Product Change Notice (PCN)

PCN Number: PCN-0334199R-01

Product(s) Affected: *CMM-4030DT-26164-TR*

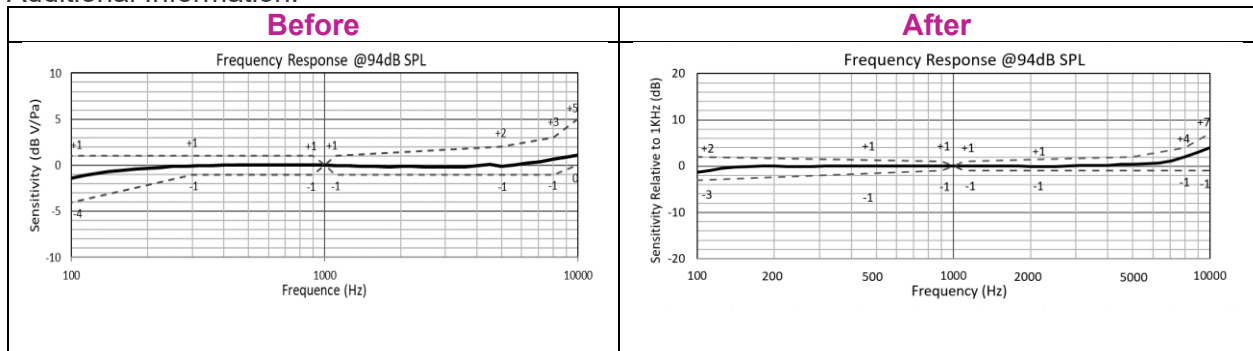
Reason(s) for Change: *Updated design and internal chip.*

Description of Change: *External color is lighter and the sound hole is now surrounded by a larger copper area. Standard performance mode has changed from a maximum of 4.0MHz to a maximum of 4.8MHz. Wake time maximum has been increased from 200µm to 20ms. Please see frequency graph comparison pictured in "Additional Information".*
